Addendum #1

Sioux Falls Department of VA
Specialty Med Addition
Sioux Falls, South Dakota

001

TSP PROJECT NUMBER: 04131193
VA# VA-263-P-1227

**4A****ADD01-S1 EXISTING CHANNEL DETAIL**

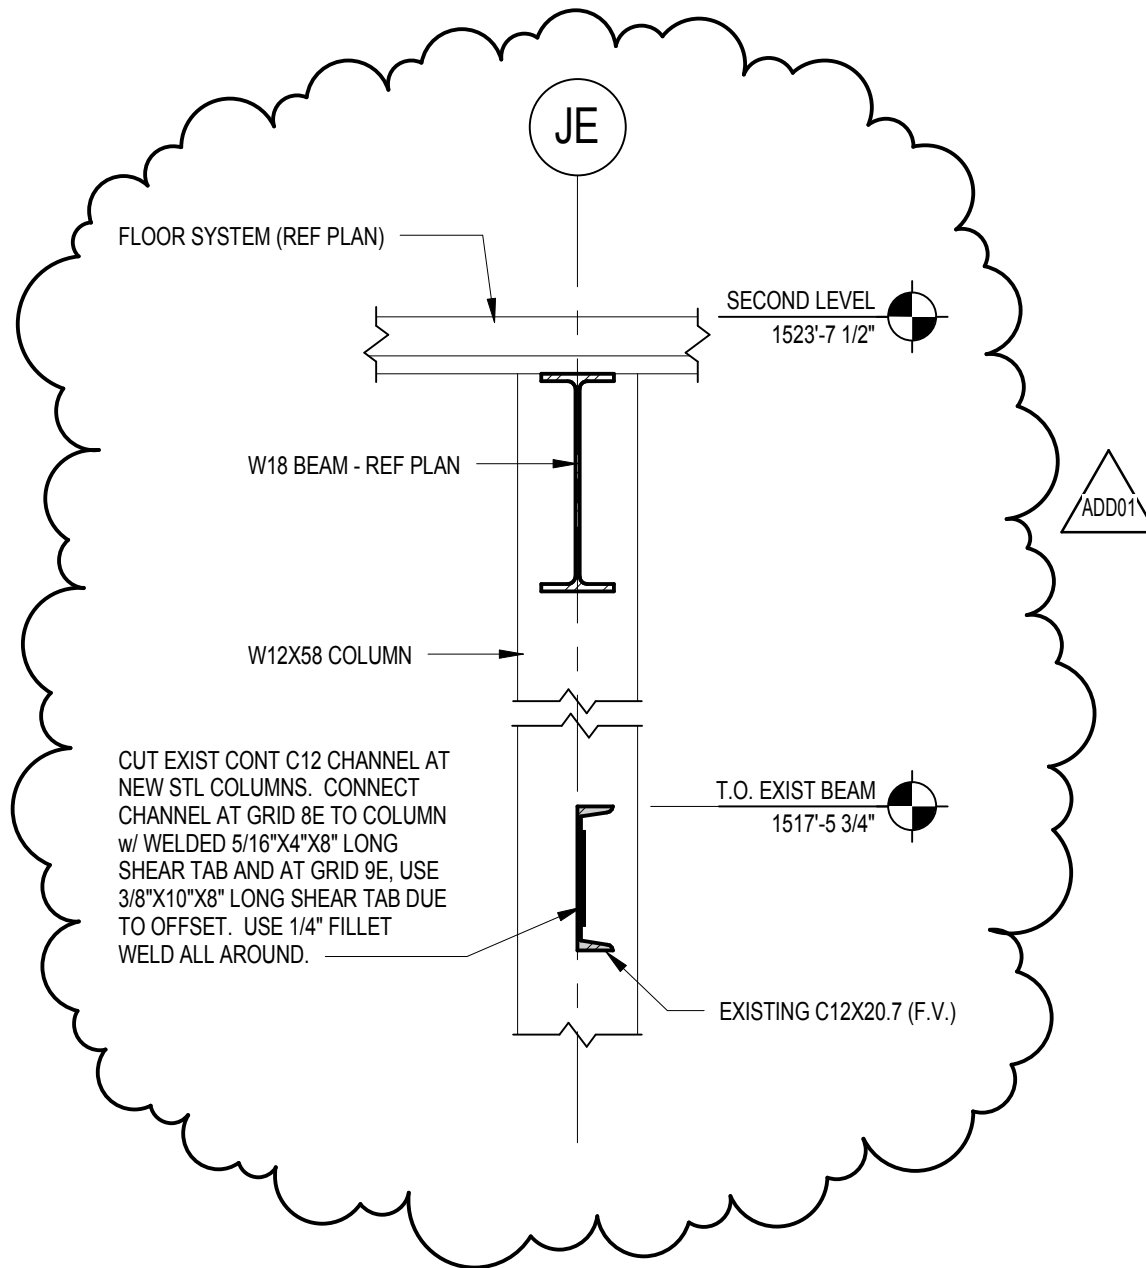
- ITEM NO: 3: Reference Drawing 5.SF102, Second Level Floor Framing Plan:
Dimension between Grids IE and JE should read 20'-4".
- ITEM NO: 4: Reference Drawing 5.SF102, Second Level Floor Framing Plan:
Existing C12x20.7 channel exists between Grids 13 and 15 along Grid JE. Top of existing channel is at 1517'-5 3/4" and supports the existing 3 inch roof deck. Cut the existing continuous C12 channel at new steel column locations along Grid JE. Connect channel at Grid 8E to steel columns w/ welded 5/16"x4"x 8" long shear tab and at Grid 9E, use a 3/8"x10"x8" long shear tab due to offset. Use 1/4" fillet weld all around. Reference attached Drawing ADD01-S1.

- ITEM NO: 5: Reference Drawing 5.SF103, Roof Framing Plan:
Dimension between Grids IE and JE should read 20'-4".
- ITEM NO: 6: Reference Drawing S-F501, Structural Framing Details:
Add new detail 4A – Existing Channel Detail; reference attached Drawing ADD01-S1.
